PCN#20191212001.1
New Tray for Select Devices
Final Change Notification

PCN Number:	20191212001.1		PCN Date:	Jan. 14, 2020
Title:	New Tray for Select Devices			
Customer Contact:	PCN Manager	**Dept:**	Quality Services	
Proposed 1st Ship Date:	April 14, 2020			
Change Type:

Group 1 Change Description - 14 x 14 TQFP Tray Change:

Group 3 Change Description - 13 x 13 BGA Tray Change:

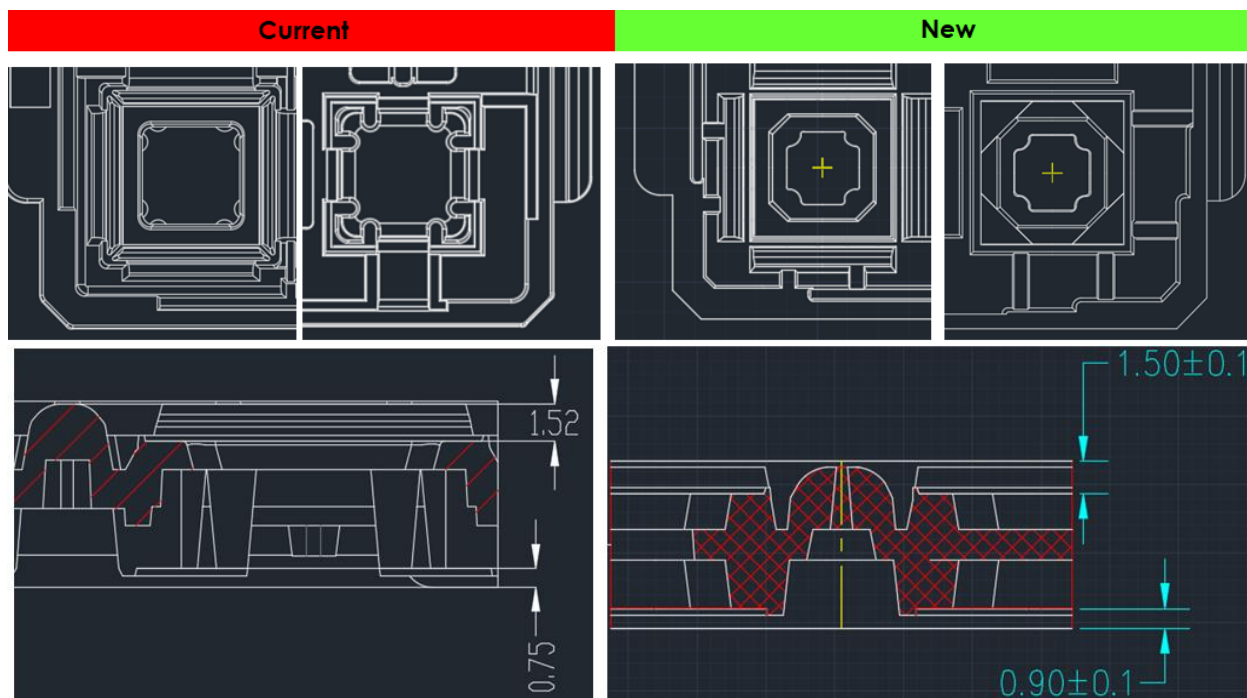
4223432-0001	4224972-0001
Supplier	UBOT	Peak
Floor design	Circular square	Octagon
Cavity size	16.55 +/- 0.08	16.10 +/- 0.08
Seating height	1.52 mm (top) 0.75 mm (bottom)	1.5 mm(top) 0.9 mm (bottom)

EXISTING 4223432-0001	PROPOSED 4224972-0001	COMMENT CHANGE
* Supplier Part Number :	UQ1414 1.0 0615XB	ND 1414 1.0 0615 13 REV.G	CHANGE
* Gram Weight:	155	157	CHANGE
*Surface Resistivity :	10^4 - 10^10 ohm/sq	10^4 - 10^10 ohm/sq	UNCHANGE
* Package Size :	14x14x1.0	14x14x1.0	UNCHANGE
* Package Type :	TQFP	TQFP	UNCHANGE
Temperature Rating :	150C	150C	UNCHANGE
Matrix (Column X Rows) :	06x15	06x15	UNCHANGE
Fence design	Fillet	Fillet	UNCHANGE
Raw Material :	Carbon Fiber	Carbon Fiber	UNCHANGE
Color :	BLACK	BLACK	UNCHANGE
FLOOR DESIGN			CHANGE

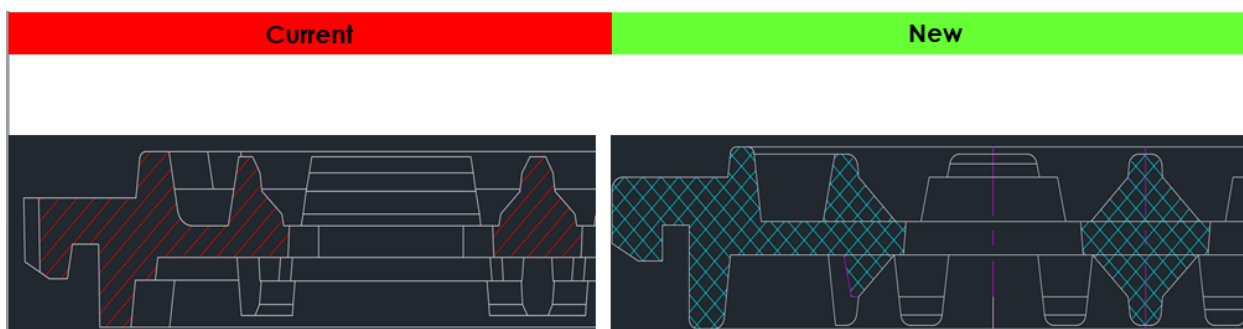
4212436-0001	4224857-0001
Supplier	UBOT	Peak
Tray Fence	Chamfered	Fillet
Cavity size (LSL)	13.30 + 0.08 13.30 - 0.04	13.30 + 0.08 13.30 - 0.08
Seating ht	1.64 mm (top) 2.00 mm (bottom)	1.27 mm(top) 1.37 mm (bottom)

MATERIAL DESCRIPTION	EXISTING 4212436-0001	PROPOSED 4224857-0001	COMMENT CHANGE
* Supplier Name :	UBOT	Peak	CHANGE
* Supplier Part Number :	UB13131.40820XB	NX BG1313 1.74 0820 13	CHANGE
* Gram Weight:	110	132.5	CHANGE
* Surface Resistivity :	1 exp5 - 1 exp11	1 exp5 - 1 exp11	NO CHANGE
* Package Size :	13x13	13x13	NO CHANGE
* Package Type :	BGA	BGA	NO CHANGE
Temperature Rating :	150C	150C	NO CHANGE
Matrix (Column X Rows) :	8x20	8x20	NO CHANGE
Raw Material :	Carbon fiber	Carbon fiber	NO CHANGE
Thickness :	7.62 mm	7.62	NO CHANGE
Color :	BLACK	BLACK	NO CHANGE
Floor Design	Yes	Yes	NO CHANGE
